Part Change Notice**Date: Dec. 20, 2015****PCN. No: 1514011****Products:**

STD-302N-R 869 MHz.

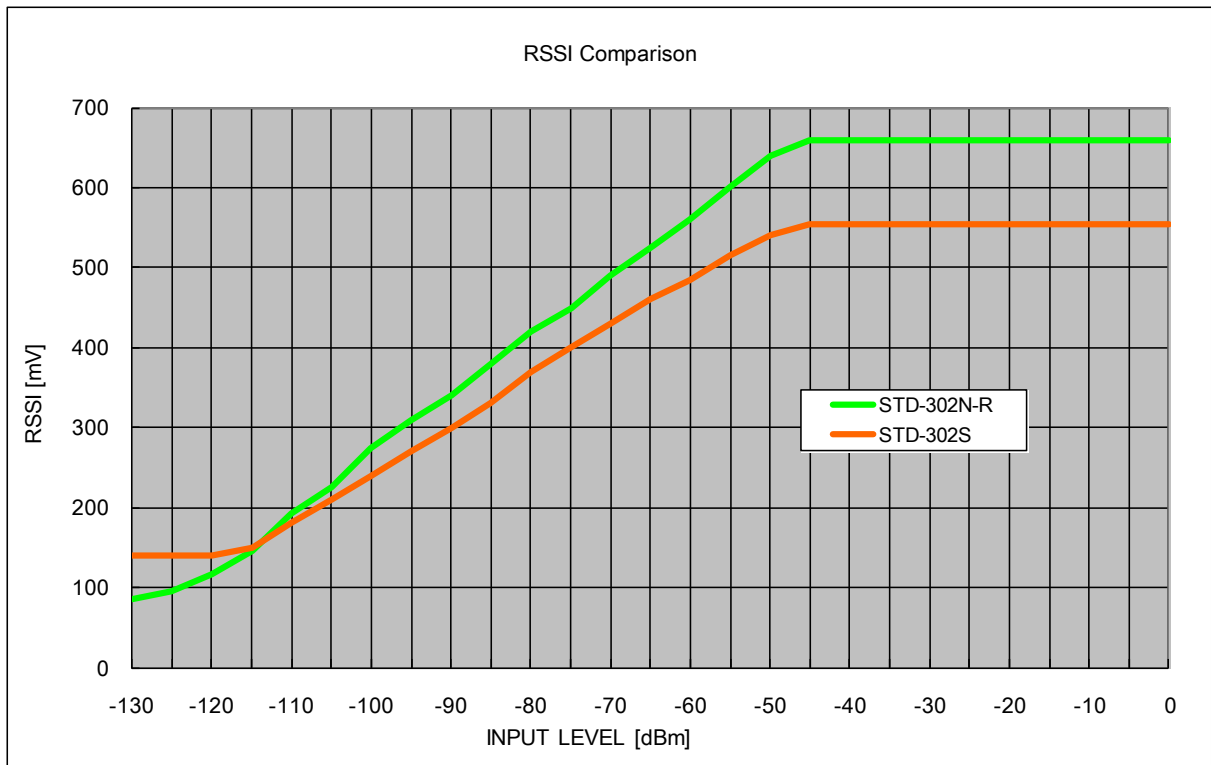
- Obsolete components are changed.
- Modulation circuit consisting of LPF using transistors, R, C and crystal is changed to 5th order LPF using op-amp and VTCXO.
- There is no change in the product specification.

Product name: STD-302N-R → STD-302S

- STD-302N-R contains several obsolete components whose production discontinuation has been announced by part suppliers. In order to continue stable product supply, these components are changed to the latest components. Modulation circuit is also changed to improve the circuit performance.
